Objection submission COM/2019/81 -

Environmental Authority EA0002207 Noise Limits will be exceeded for foreseeable future

## Attachment B1 - Noise Levels in Residential areas above Environmental Limit ( 45 dB(A) )

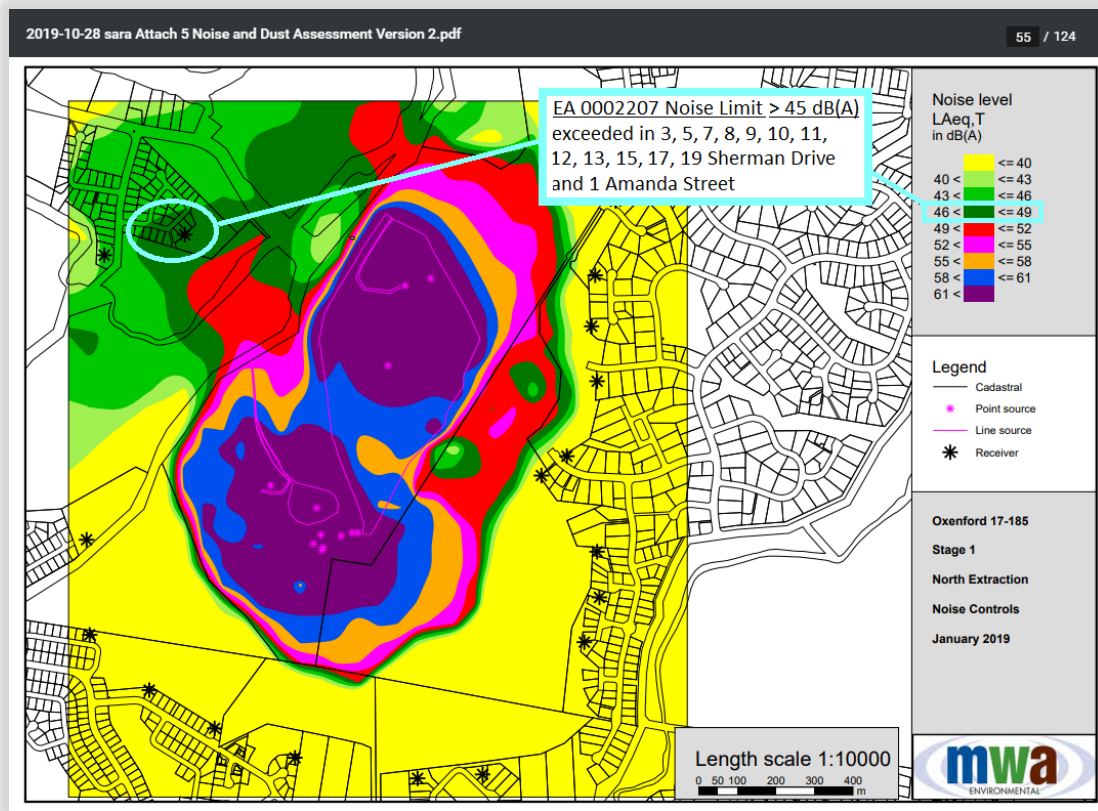
The submitted noise plan shows clearly that 'noise sensitive places' in the form of 'Dwellings' (residential homes) in the west will receive noise levels above the upper limit of 45 dB(A) as specified in the Environmental Authority (reproduced in Attachment B1).

Attachment B2 is a Google Earth view highlighting that the following homes are all guaranteed (according to the submitted DA noise plan, Attachment B1) to receive noise levels above the Environmental Authority upper limit:

- 8 Sherman Drive
- 10 Sherman Drive
- 12 Sherman Drive
- 3 Sherman Drive
- 5 Sherman Drive
- 7 Sherman Drive
- 9 Sherman Drive
- 11 Sherman Drive
- 13 Sherman Drive
- 15 Sherman Drive
- 17 Sherman Drive
- 19 Sherman Drive
- 1 Amanda Street

How can this development application ever be approved when, on its own omission, it cannot meet the required Environmental Authority EA0002207 noise limits for dwellings in the area?

Attachment C1 - Noise Levels in Surrounding areas well above Environmental Limit ( 45 dB(A) )

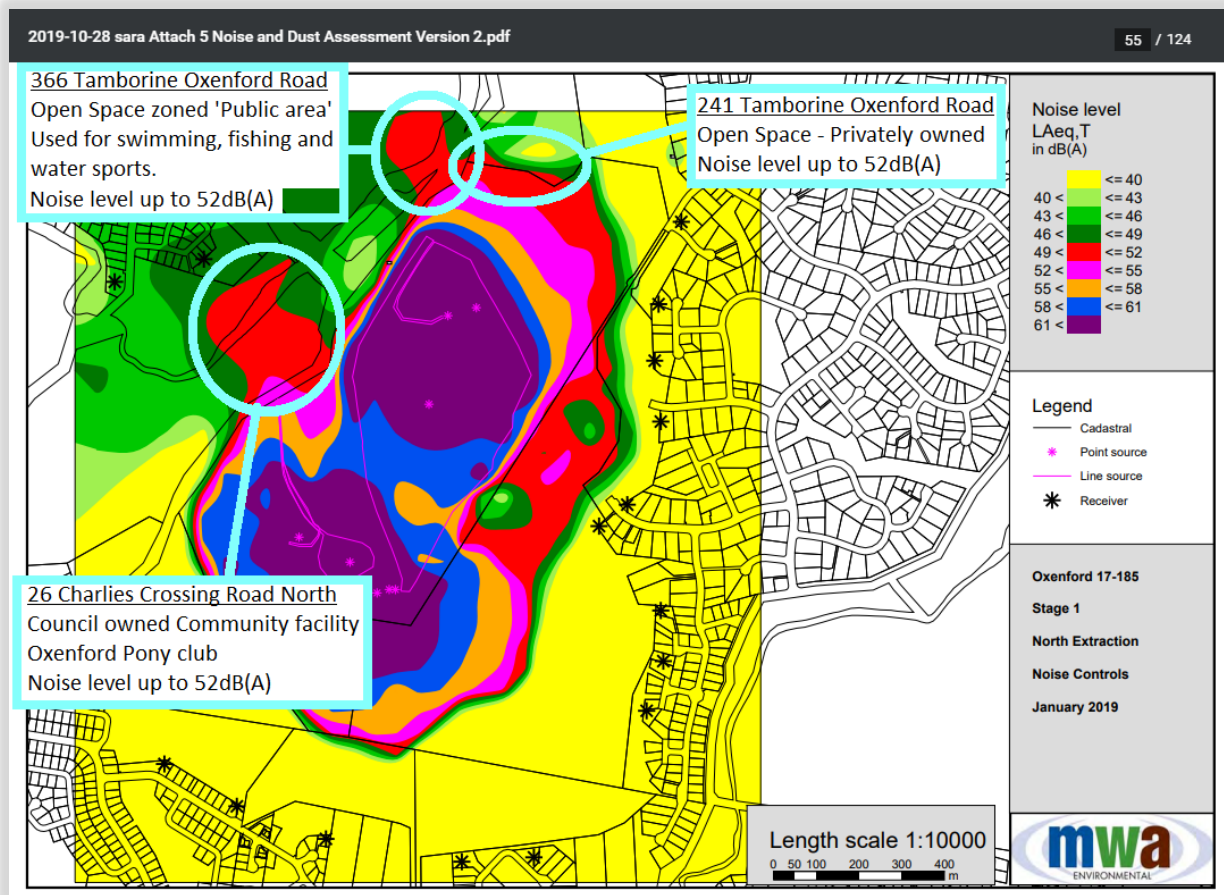
Public areas will also be subjected to noise levels above the environmental Authority as shown in Attachment C1.

For instance, the Coomera Freshwater lake, regularly used by swimmers (Attachment C2) and fishermen (Attachment C3), is a mere 120 m approx from the proposed extractive footprint, will be subjected to noise levels way above the noise limit of 45 dB(A) at up to 52 dB(A).

Also, '241 Tamborine Oxenford Road', an open space zoned lot, not owned by the applicant, but adjacent to the proposed extractive footprint will also be subjected to noise levels way above the noise limit of 45 dB(A), at up to 52 dB(A), as shown in attachment C1.

## Attachment C4 - Oxenford Community Pony Club (Noise limit well above Environmental Limit)

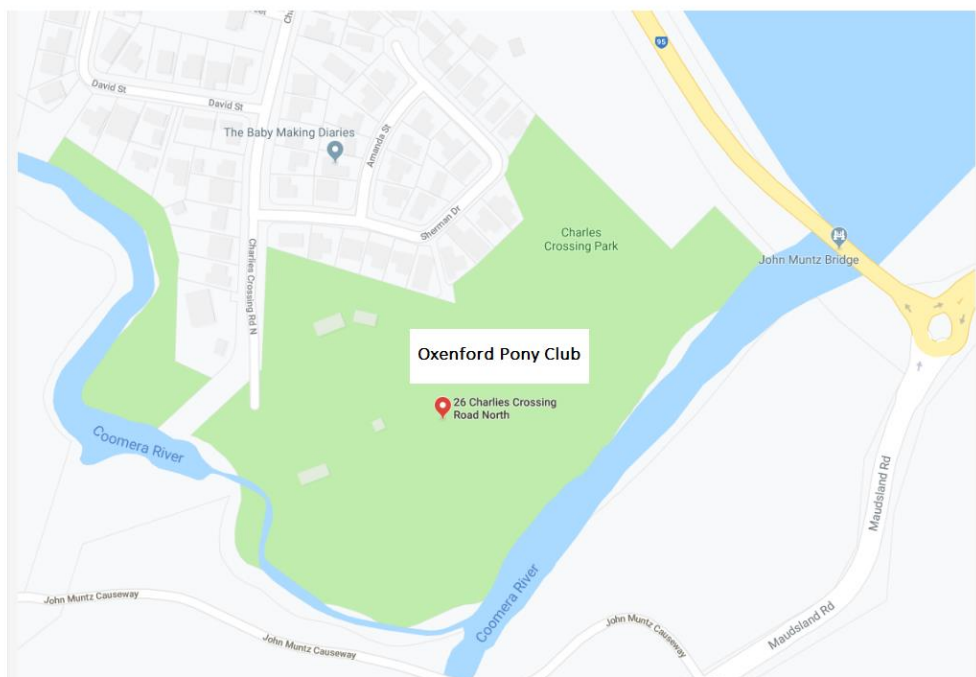
Similarly, the Council owned Oxenford Community Pony Club (Attachment C4) will also be subjected to noise levels way above the noise limit of 45 dB(A) at up to 52 dB(A).

These are all, I believe, 'Noise sensitive places' covered by: "*h). A park or garden that is open to the public (whether or not on payment of an amount) for use other than for sport or organised entertainment*" (Attachment A2).

## Attachment D1 - Lot Identification

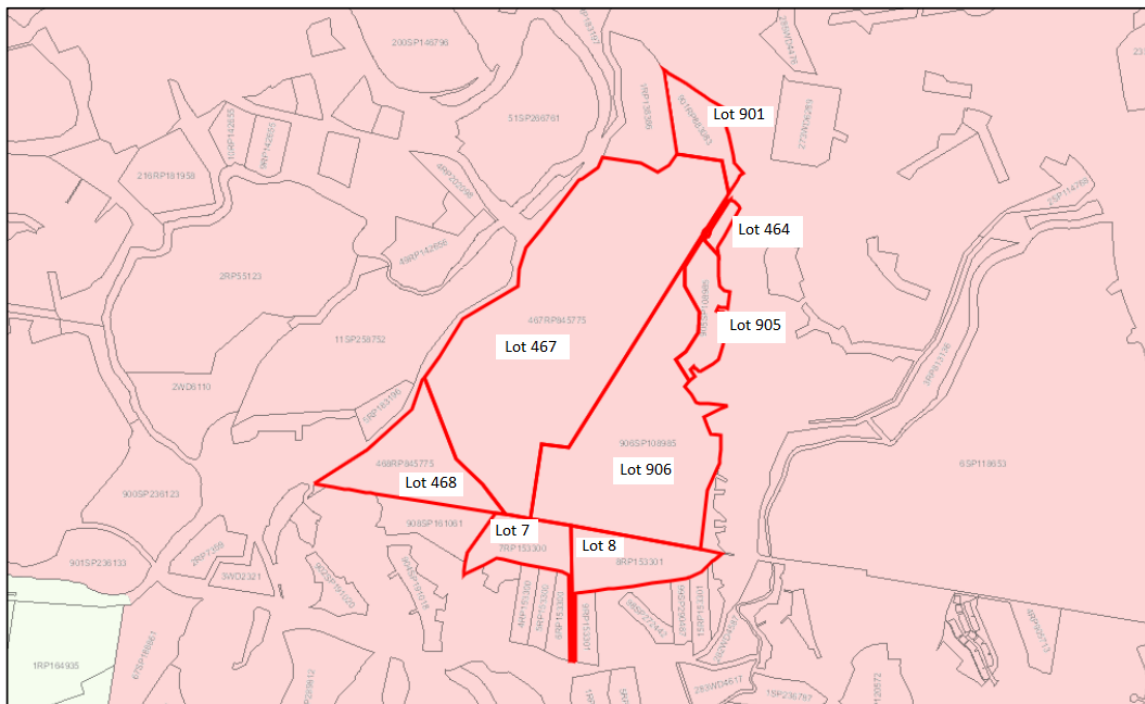
Lot 906, the 'Quarantined Land' area (identified in attachment D1), to the east of the proposed extractive footprint, will be subjected to noise levels above the environmental Authority EA0002207 as shown in Attachment D2.

## Attachment D2 - Lot 906 subjected to noise levels well above the EA0002207 limit of 45 dB(A)

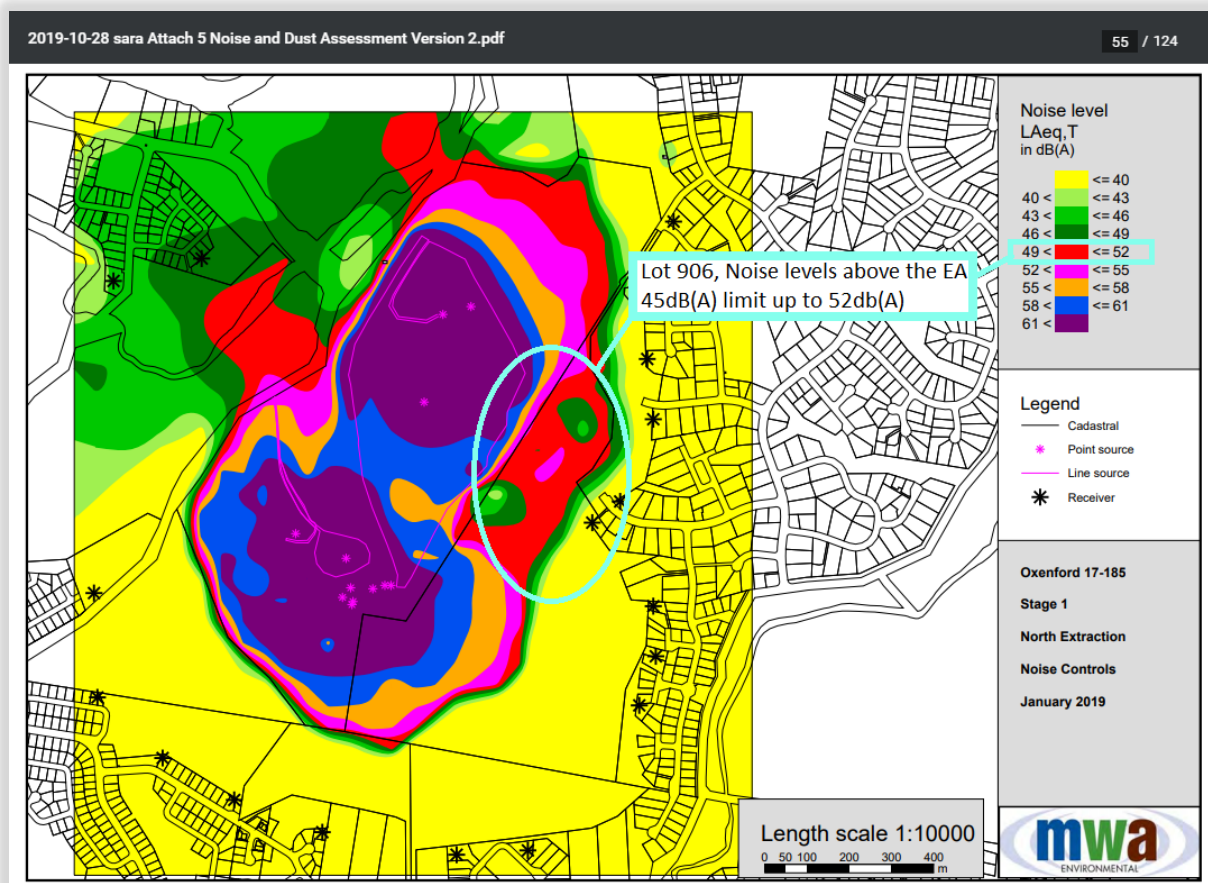
However, it is part of the 'Hinterland to coast critical corridor' i.e. it identifies corridors that connect large areas of intact native vegetation in the City's west to coastal areas in the east (Attachment D3). It is also identified as 'Core Koala Habitat area' (Attachment D4 and attachment D5).

This is a 'Noise sensitive place' covered, I believe, by: "*f). A protected area, or an area identified under a conservation plan as a critical habitat or an area of major interest, under the Nature Conservation Act 1992*" (Attachment A2).

How can this development application ever be approved when, on its own omission, it cannot meet the required Environmental Authority EA0002207 noise limits, as specified in Attachment A1, for 'noise sensitive places'?

## Attachment F3 - Main Processing Plant noise output 123 dB(A)

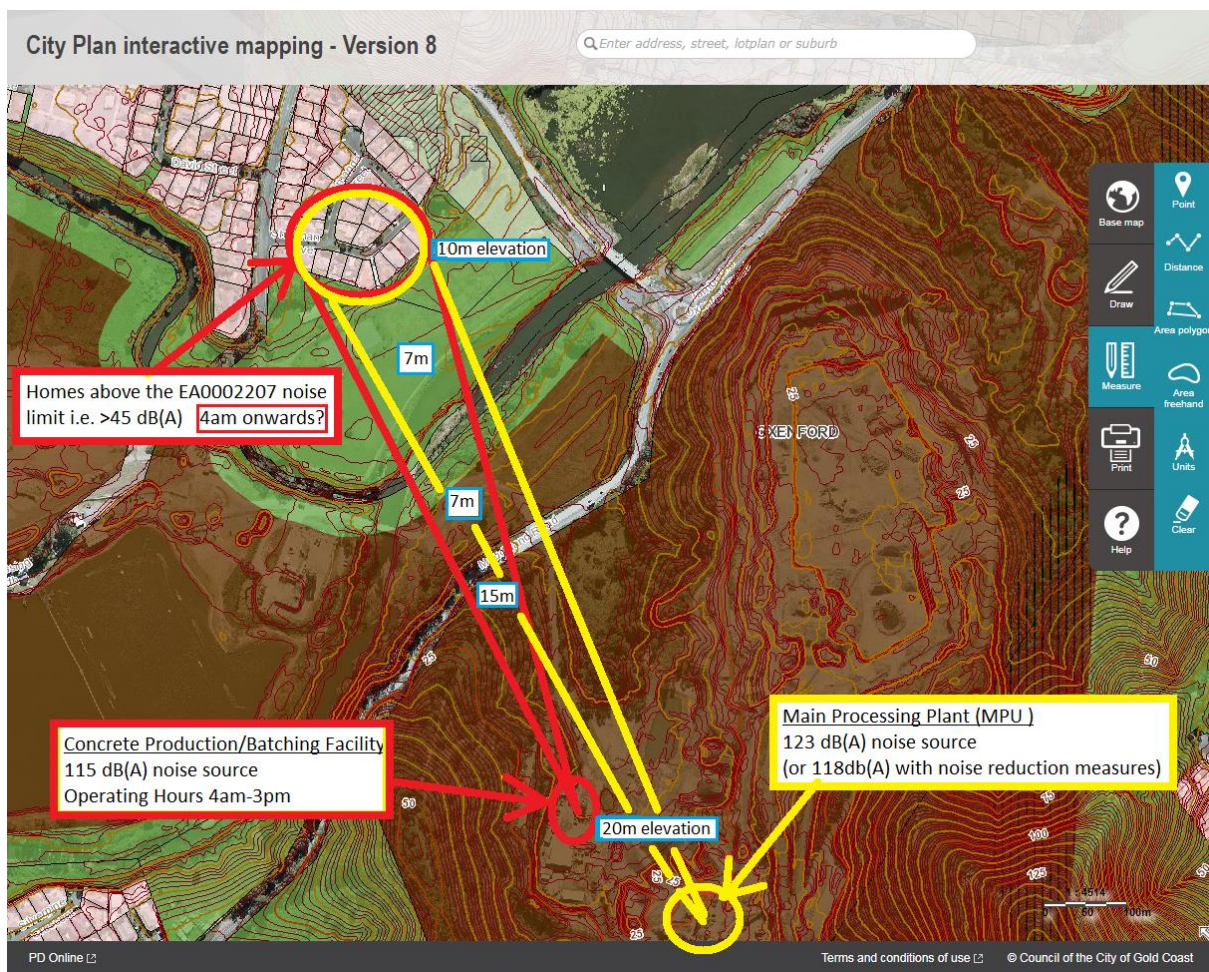
From the DA, the level of noise output from the Main Processing Plant is 123 dB(A) (as shown in attachment F3).

Further, based on just the output from the Main Processing Plant (and assuming the 5 dB(A) noise suppression has been added to reduce the noise output from 123 dB(A) to 118 dB(A) as described in attachment E1), it can be seen that the noise level at Sherman Drive will be above the EA limit of 45 dB(A) 48 dB(A) (*'Source 2'* in Attachment F5).

## Attachment G1 - Concrete Plant Operating Hours

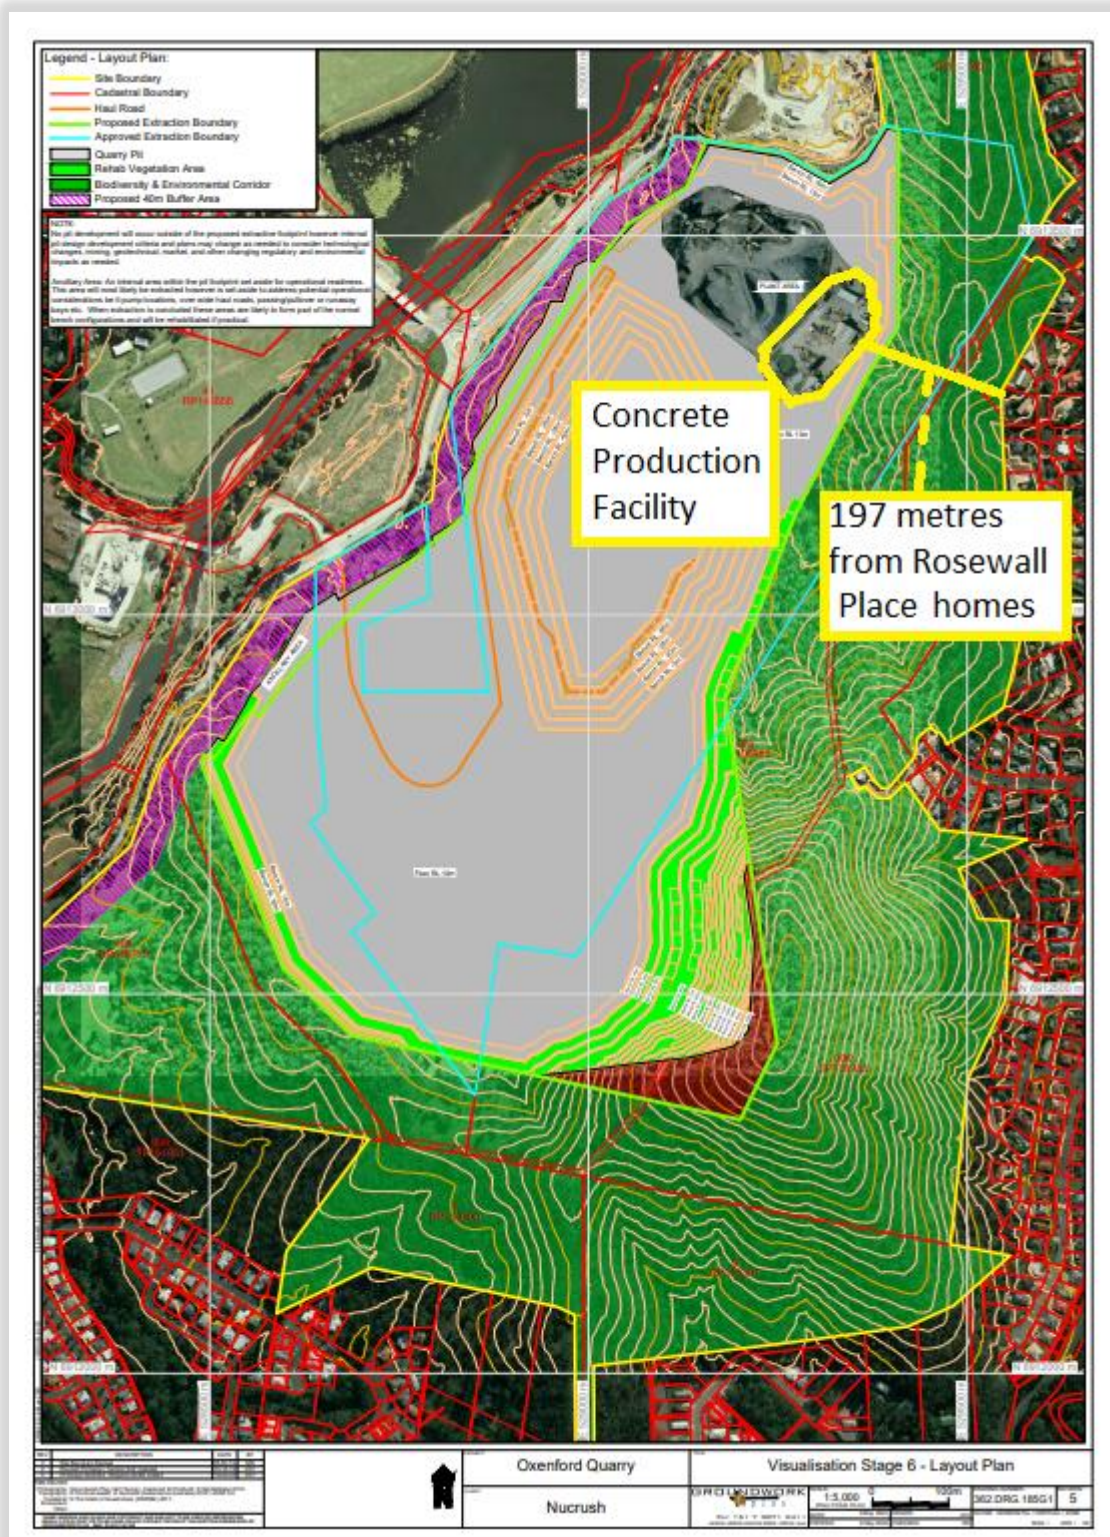
It is not only extremely worrying to note, just the Concrete Production plant will exceed the Environmental Authority limit on a constant basis but also it has been bestowed by the Council the beneficial operating hours beginning at 4am (October to April) and 5am for the remaining five months (Attachment G1).

Between the hours of 4am (or 5am May-Sep) and 7am it is proposed that the Concrete production / batching plant will be in operation (and associated haulage trucks, loaders and concrete trucks) as shown in DA submission (reproduced in Attachment G1). It is claimed in the DA that the sound output from the Concrete plant will be 115 db(A) (attachment F2). This is 671 metres from the closest residential 'noise sensitive places' (these being homes in Sherman Drive, Upper Coomera) for proposed stages 1 to 5 (first 37 years of operation - attachment A3). From the noise calculator it can easily be established that the approximate noise level will be in the region of 47 dB(A) at the 'noise sensitive places' (ignoring the truck output and any other cumulative output). This is way above the 30 dB (A) noise limit between 10pm and 7am.

## Attachment H2 - Noise plan Stage 6

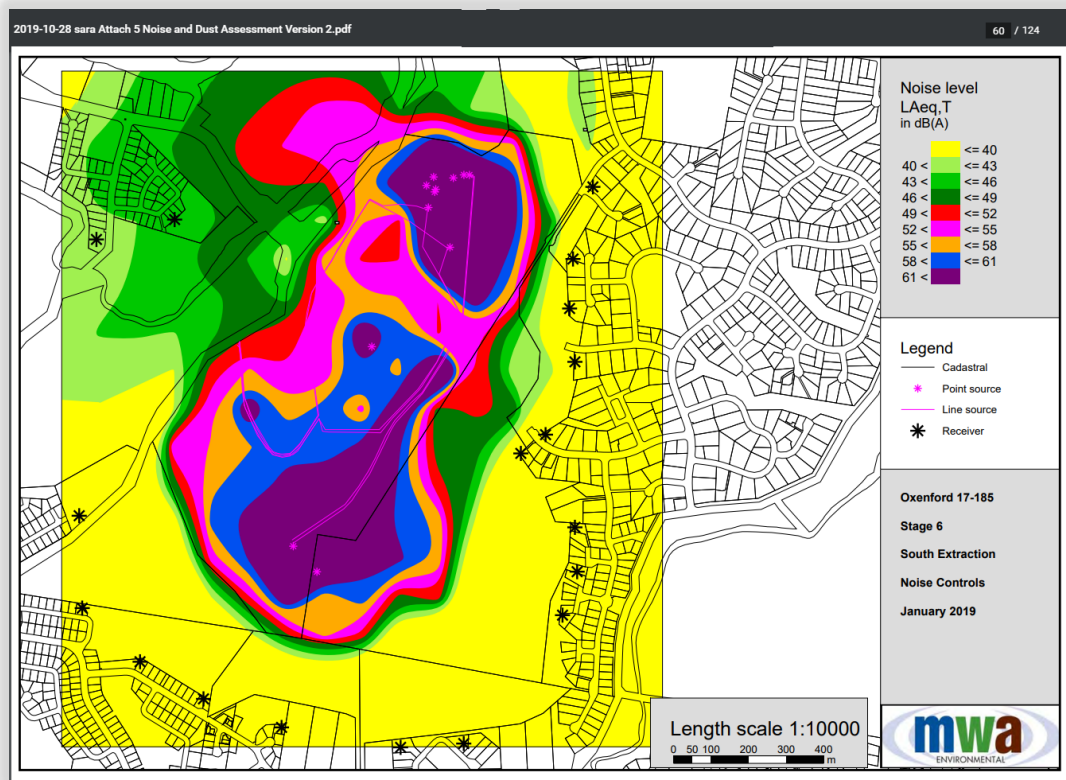
The submitted Noise Plan for Stage 6 is reproduced in Attachment H2. However, comparing the position of the Concrete Plant in attachment H1 and attachment H2 it can be seen that the noise plan has the concrete production plant in the wrong location and is in fact approximately 60 metres further left than it should be (Attachment H3). As in this location it would impede on the car parking area (Attachment H4) I assume the correct position is as shown in the '*Visualisation Stage 6 layout plan*' (Attachment H1).

It is noted that these calculated levels are far, far higher at '*noise sensitive places*' shown on Stage 6 Noise Plan (Attachment H2). My calculations indicate 59 dB(A) whereas submitted plan shows this to be less than 40 dB(A). A considerable difference. I note there is a degree of topography between the extractive footprint and the '*noise sensitive places*', however, I do not believe it will result in such a
